BAYLESS TAYLOR DAM
BOLLINGER COUNTY, MISSOURI
MISSOURI INVENTORY NO. 31091

PHASE I INSPECTION REPORT
NATIONAL DAM SAFETY PROGRAM

PREPARED BY: ST. LOUIS DISTRICT CORPS OF ENGINEERS
FOR: GOVERNOR OF MISSOURI

MARCH 1980

BAYLESS TAYLOR DAM
CROSS-SECTION THROUGH
DISCHARGE PIPE
1974 DRAWINGS
PLATE 5

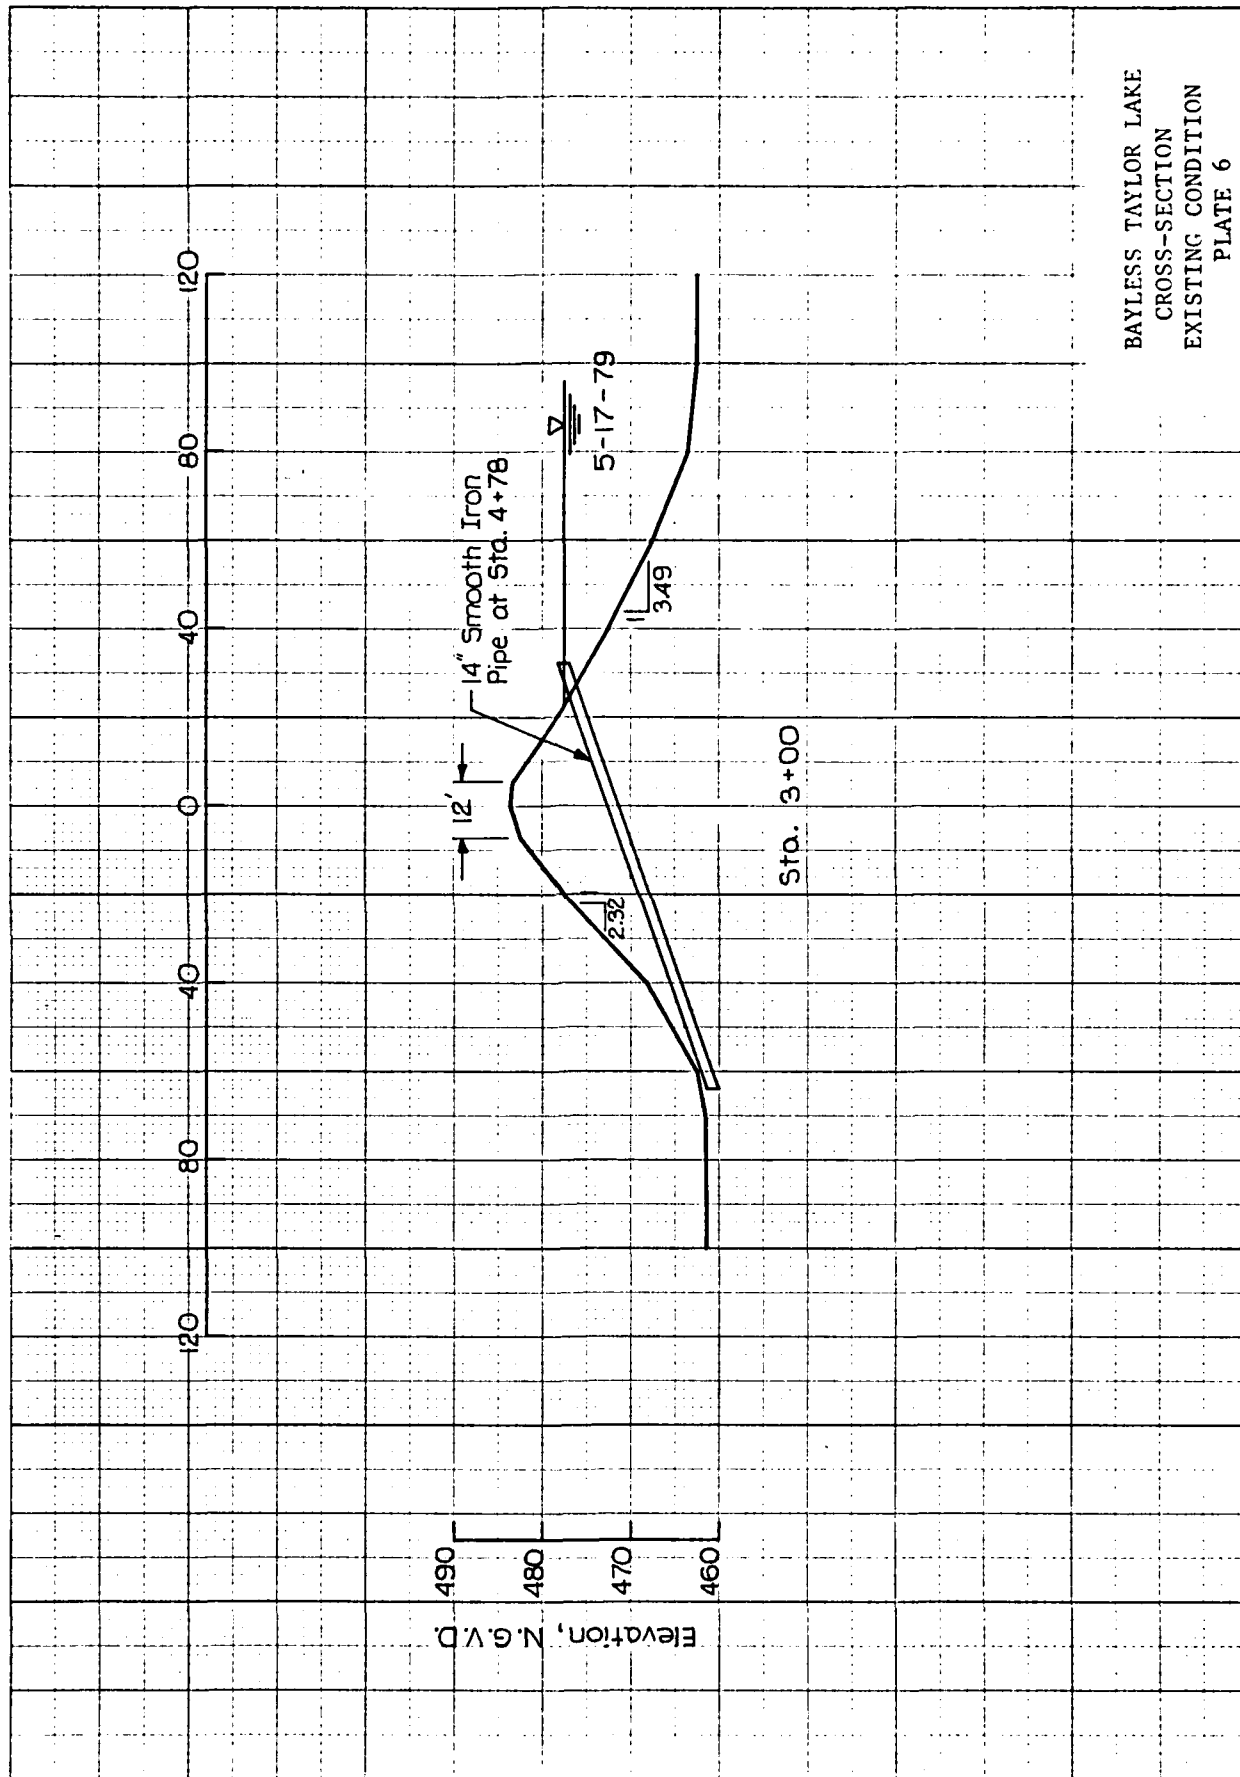
b. Dam. No detrimental settlement, cracking, slides, or animal burrows were observed in or near the earthen embankment. A typical existing cross-section of the embankment is shown on Plate 6. This section is consistent with the cross-section presented in the Soil Conservation Service 1974 drawings (See Plate 5) except the downstream slope is 1V on 2.32H and the upstream slope is 1V on 3.49H. The top width was measured to be 12 feet. The maintenance of the upstream slope, crest, and downstream slope was satisfactory. (See Photo's 1, 2, 3, 4, 5) About 1½ feet of wave wash occurs near the left abutment (See Photo 5). Minimal willow tree growth occurs on both the upstream slope and on the downstream toe of the embankment (See Photos 4 and 6). Also small tree and bush growth was observed on the right downstream abutment.
